City of Fayetteville, Arkansas

Planning Commission Tentative Agenda

Thursday, February 19, 2026

7. LSD-2025-0021: Large Scale Development (3101 N. COLLEGE AVE/ARMOR BANK, 252):

Staff Exhibit: Applicant Fence Photos

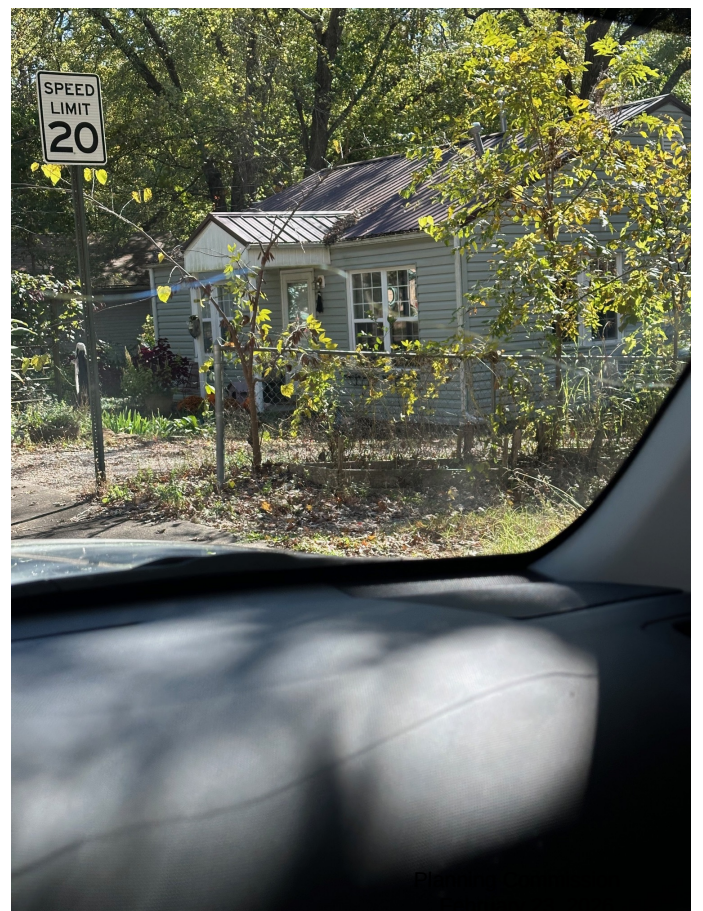
Request: The applicant is requesting three variances from the Unified Development Code in association with a fence that was recently constructed.

Variance #1: UDC §164.09(B)(b), Chain Link – Chain link fence is prohibited if closer to the street than the front of the building. The applicant is requesting to vary from this standard to permit a chain link fence within their front yard.

1. **Planning Commission determination of a variance to UDC §164.09(B)(b) – Chain Link** *Staff recommends approval of this variance for the reasons stated above.*
2. **Planning Commission determination of a variance to UDC §166.21(E)(6)(b) – Height.** *Staff recommends approval of this variance for the reasons stated above.*
3. **Planning Commission determination of a variance to UDC §166.21(E)(6)(c) – Permitted Configurations.** *Staff recommends approval of this variance for the reasons stated above.*
4. Approval of this item does not constitute approval of the associated building permit, or for other variances that have not yet been reviewed for and/or requested.

PRELIMINARY
 SITE PLAN

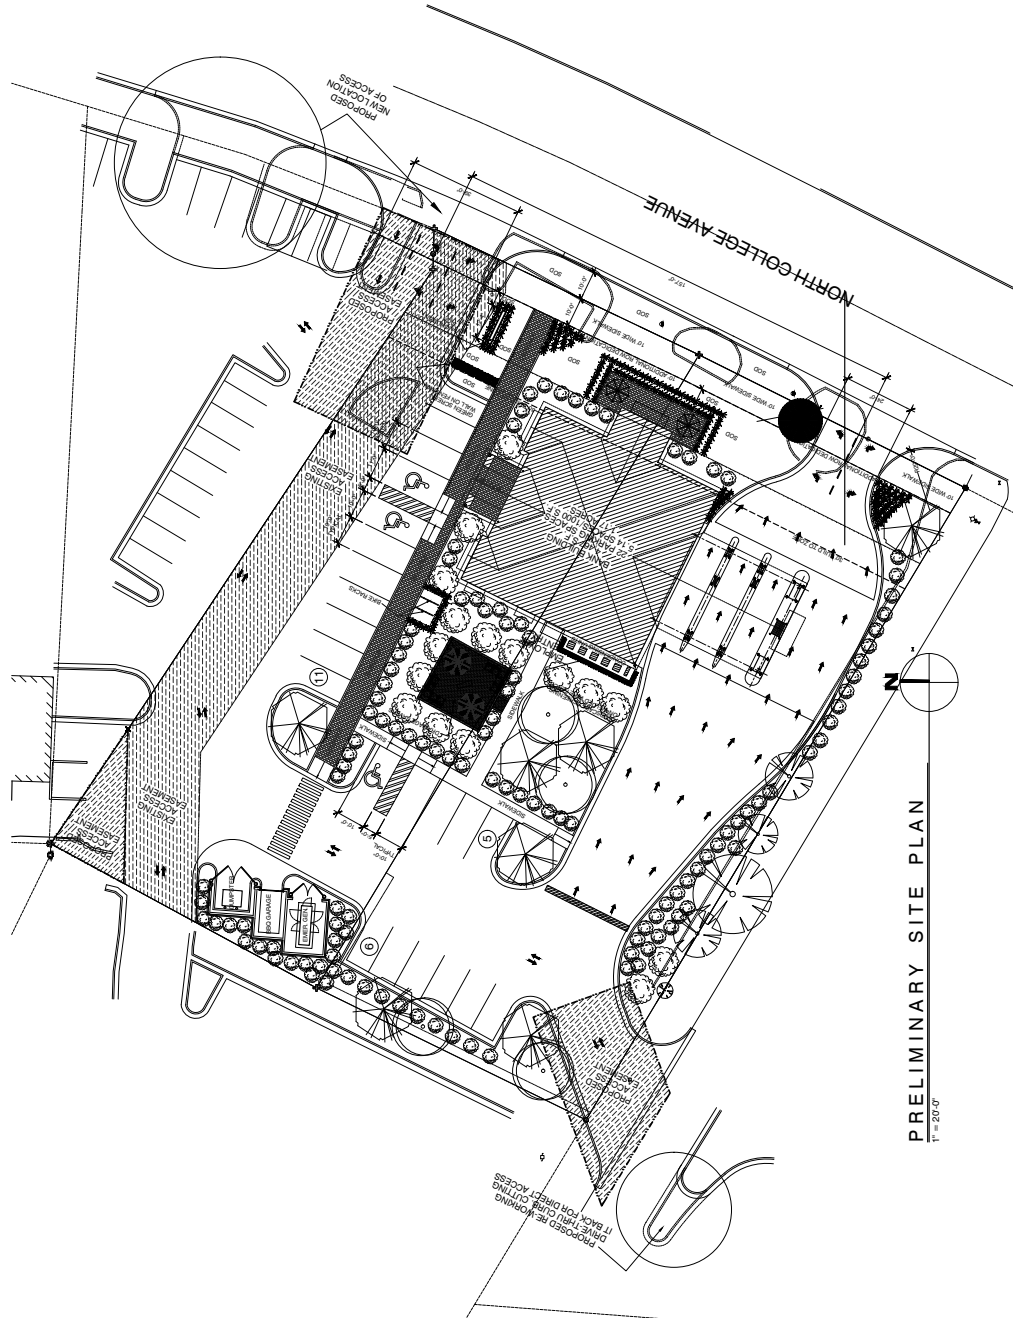
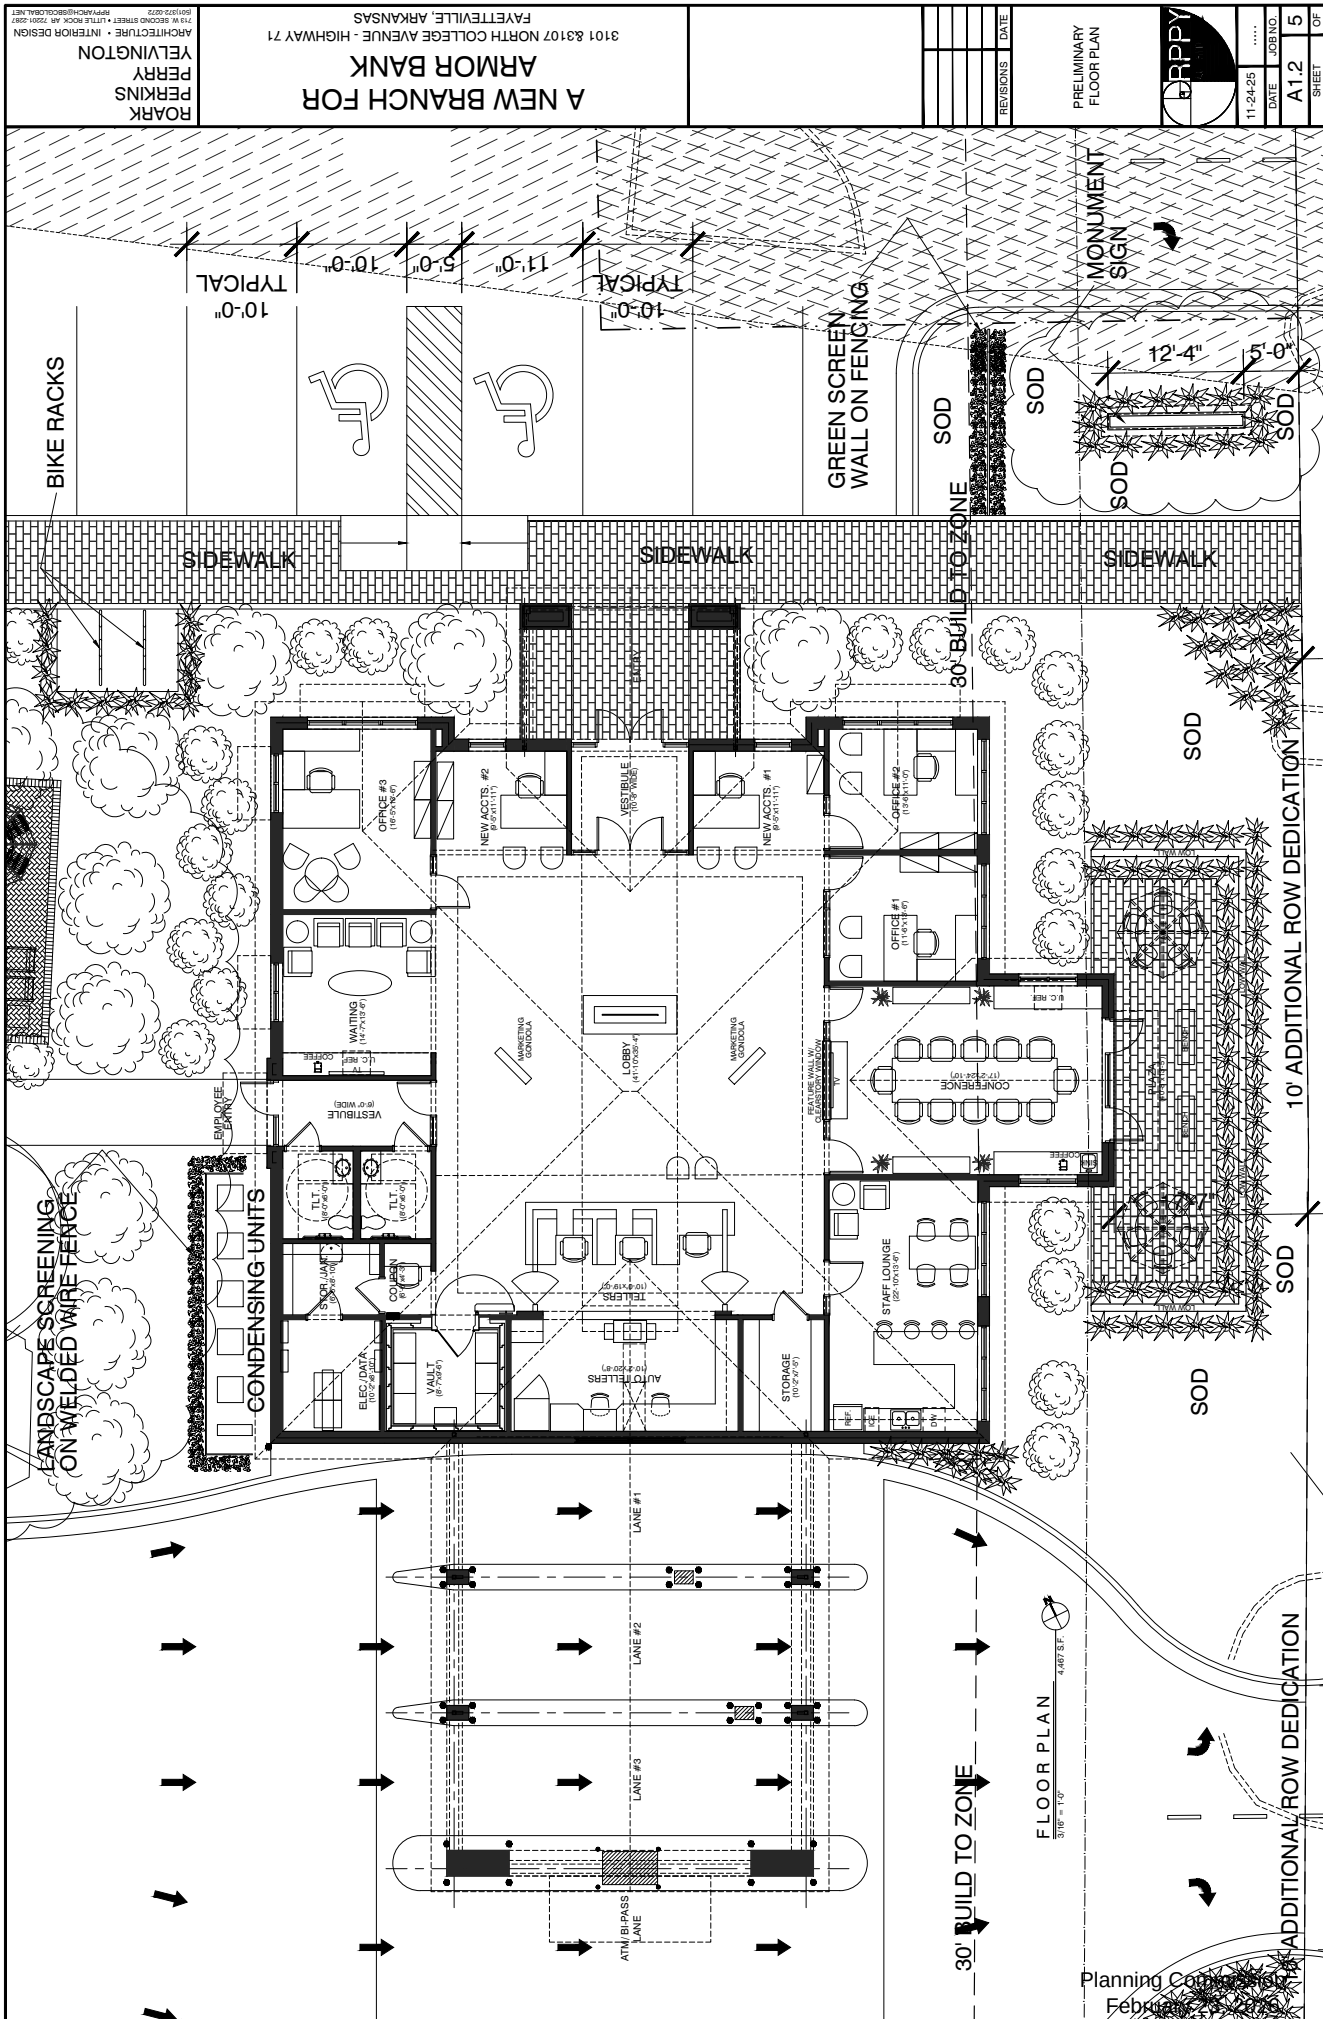
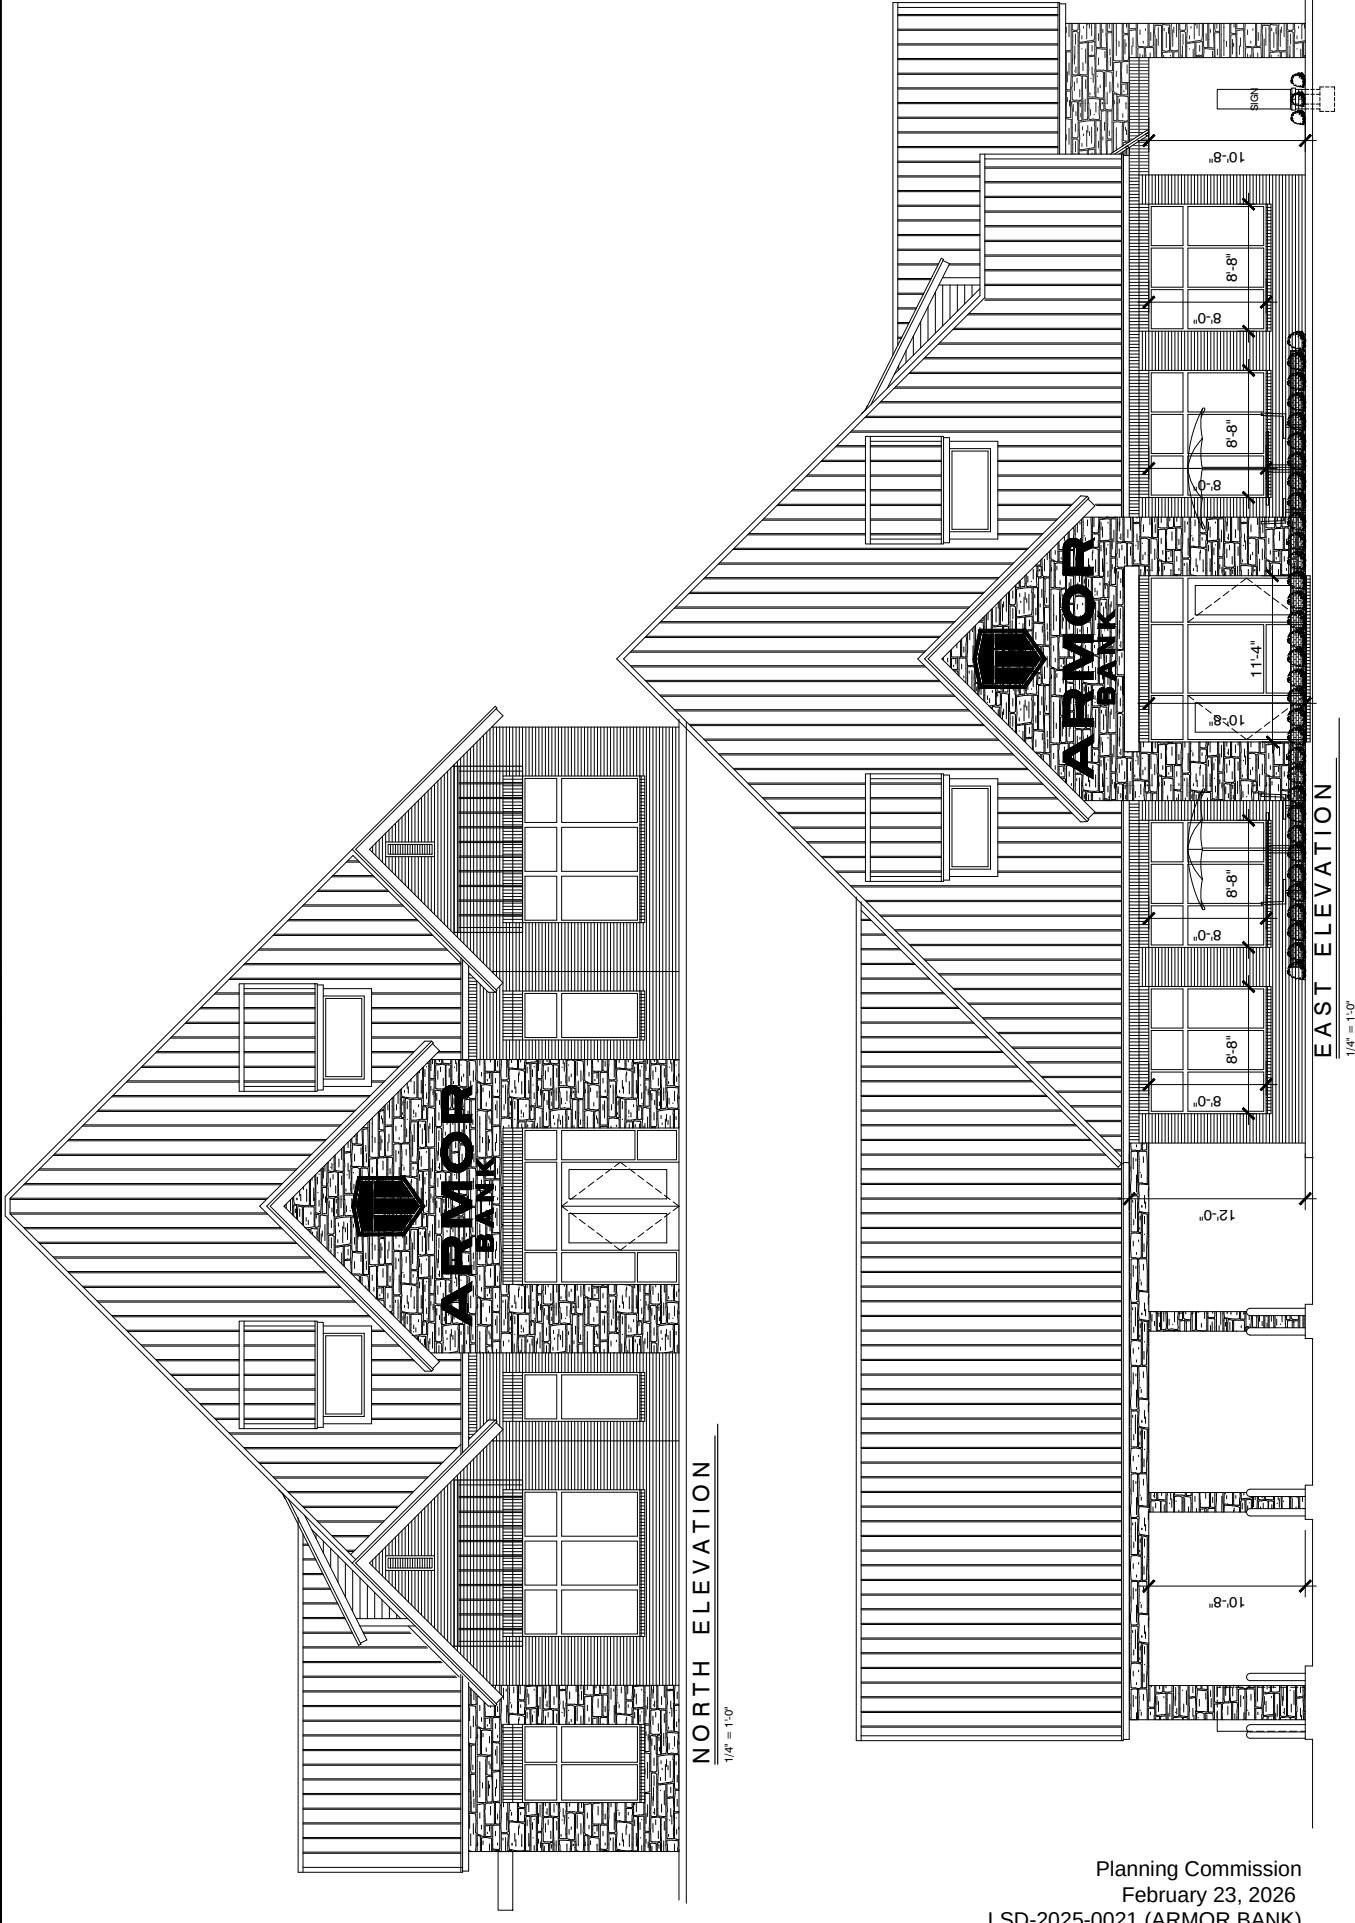
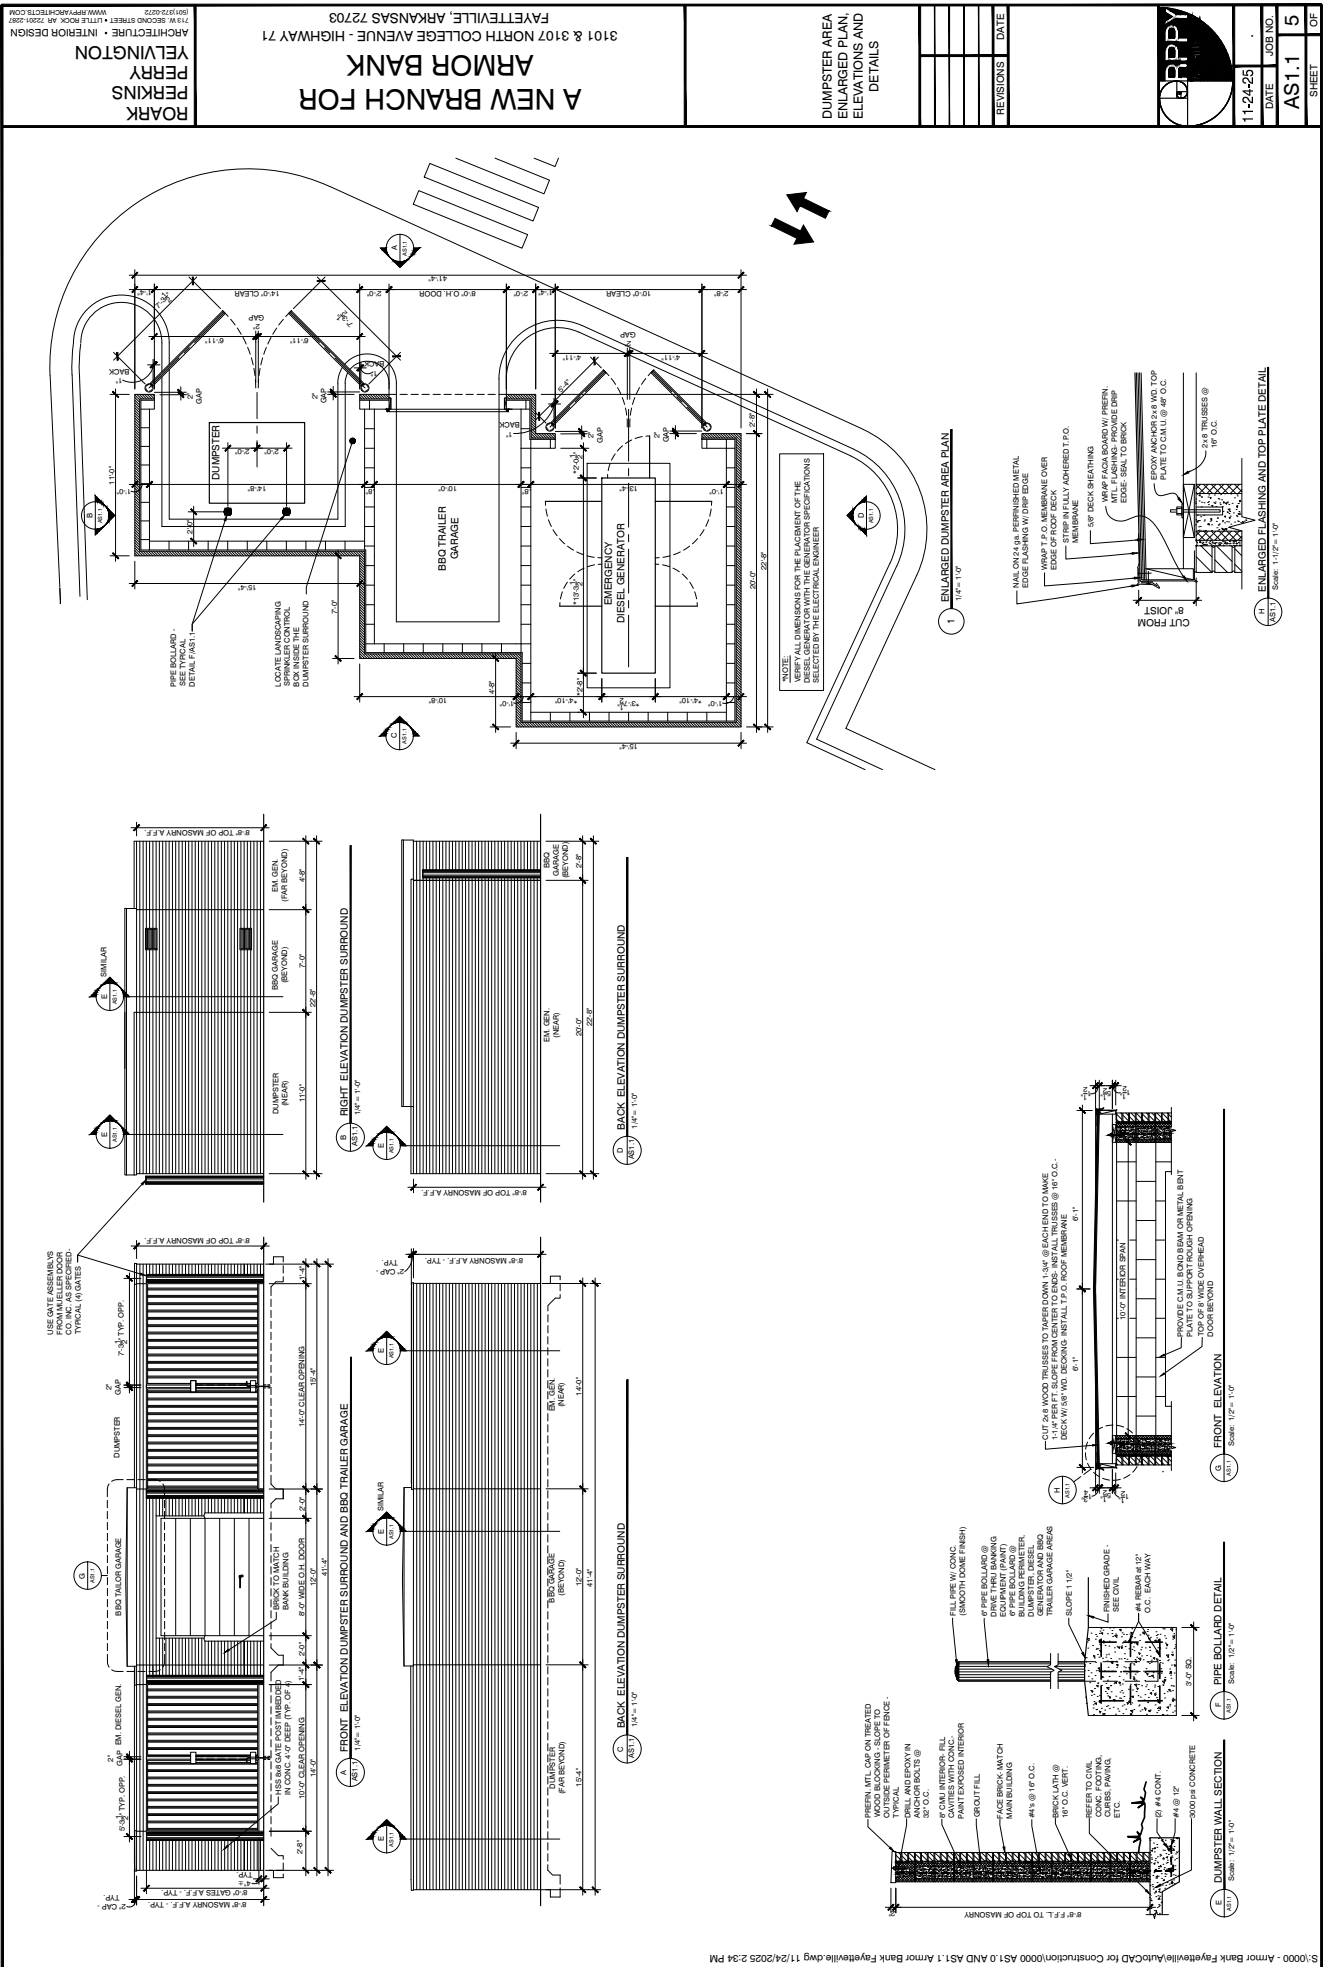
1. **Planning Commission determination of a variance to §UDC §172.04(E) Dimensional standards, which typically requires a 24-foot width for two-way drive aisles, and a standard parking space of 9 feet by 19 feet.** *Staff recommends in favor of the wider drive aisles, but against the applicant's request for larger than typical parking spaces.*

2. **Planning Commission determination of a variance to UDC §166.24(D)(7)(a): Entryways. A primary entrance for buildings located in a build-to zone shall face the public street.** *Staff recommends in favor of the request.*

3. **Planning Commission determination of a variance to UDC §166.25(C)(4) All structures shall be architecturally designed to have front facades facing all adjacent street and highway rights-of-way, and shall include at least one prominent entry-way on the principal façade(s).** *Staff recommends in favor of the request.*

4. **Planning Commission determination of a variance to UDC §166.08(F)(2)(a) Where a curb cut must access the regional link, it shall be located a minimum of 250 feet from an intersection or driveway.** *Staff recommends in favor of the applicant's request, with an added condition that the left turn from the northern driveway be removed.*

5. **Planning Commission determination of a variance to UDC §172.04(C)(1), which typically requires that a parking lot located within the build-to zone shall be screened with a masonry screen wall between 32 inches and 42 inches in height and 50% opaque minimum.** *Staff recommends in favor of the request.*

6. **Planning Commission determination of right-of-way dedication.** *Staff recommends right-of-way dedication in the following amounts:*
 - a. *N. College Avenue: minimum of 48 feet from street centerline*

7. **Planning Commission determination of street improvements.** *Staff recommends the following improvements:*
 - a. *N. College Avenue: Typical master street plan requirements for sidewalk (10 feet) and greenspace (10 feet) and streetlights as needed.*
